UNITED STATES PATENT AND TRADEMARK OFFICE

10/562,471

Office Action Summary	Application No. 10/562,471	Applicant(s) HOUSTON ET AL.	
	Examiner JOCELIN C. TANNER	Art Unit 4133

DETAILED ACTION

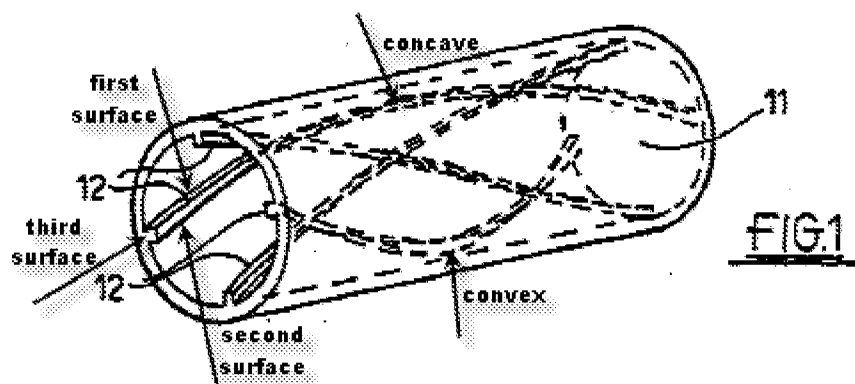
14. Regarding claim 4, Houston discloses a first surface of the longitudinally extending member (FIG. 1, element #12) that is at least partially directed towards an inlet of the conduit and a second surface of the longitudinally extending member is at least partially directed towards the outlet of the conduit.

15. Regarding claim 5, Houston discloses a first surface of the longitudinal member to have a planar portion and/or a curved portion (FIG. 1). Please see marked up figure below.

16. Regarding claim 6, Houston discloses a second surface having a planar portion and/or a curved portion (FIG. 1). Please see marked up figure below.

17. Regarding claim 29, Houston discloses a second surface having a curved portion, the curved portion being concave or convex, or a combination of concave and convex (FIG. 1). Please see marked up figure below.

18. Regarding claim 30, Houston discloses a first surface having a curved portion, the curved portion being concave or convex, or a combination of concave and convex (FIG. 1). Please see marked up figure below.

22. Regarding claim 36, Houston discloses first and second surfaces that extend from the internal surface of the conduit towards each other and towards a central longitudinal axis of the conduit (FIG.1). Please see marked up figure above.

23. Regarding claim 37, Houston discloses first and second surfaces that are coupled together at an apex or by a third surface (FIG.1). Please see marked up figure above.

24. Regarding claim 38, Houston discloses an internal formation having an apex or a third surface that is curved (FIG.1). Please see marked up figure above.

25. Regarding claim 39, Houston discloses an internal formation having a longitudinally extending member with asymmetric profile and extends along an inside surface of a conduit (FIG.1). Please see marked up figure above.

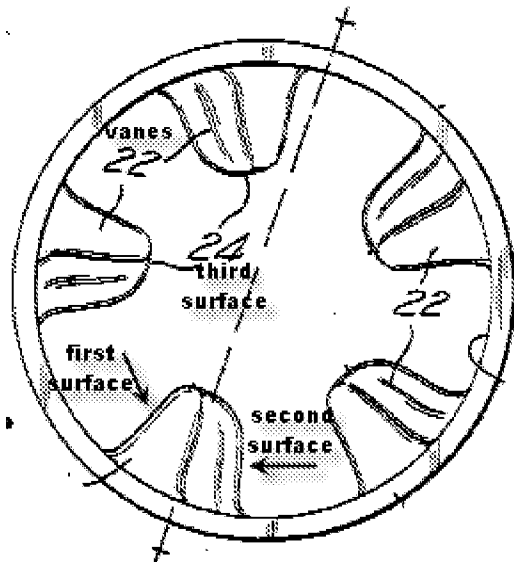
Regarding independent claim 1, Jansen discloses an internal formation for a conduit, the formation having vanes or a “longitudinally extending member” (FIG. 2, element #22) adapted to extend along an inside surface of at least a portion of the length of the conduit, the longitudinally extending member having an asymmetric profile in a direction transverse of the longitudinal axis of the member (column 2, lines 12-18, FIG 2).

39. Regarding claim 4, Jansen discloses a first surface of the longitudinally extending member (FIG. 1, element #12) that is at least partially directed towards an inlet of the conduit and a second surface of the longitudinally extending member is at least partially directed towards the outlet of the conduit. Please see figure below.

40. Regarding claim 36, Jansen discloses first and second surfaces that extend from the internal surface of the conduit towards each other and towards a central longitudinal axis of the conduit (FIG.2). Please see marked up figure above.

41. Regarding claim 37, Jansen discloses first and second surfaces that are coupled together at an apex or by a third surface (column 3, lines 13-14, FIG.2). Please see marked up figure above.

43. Regarding claim 39, Jansen discloses an internal formation having a longitudinally extending member with asymmetric profile and extends along an inside surface of a conduit (column 3, lines 16-20, FIG.2). Please see marked up figure above.
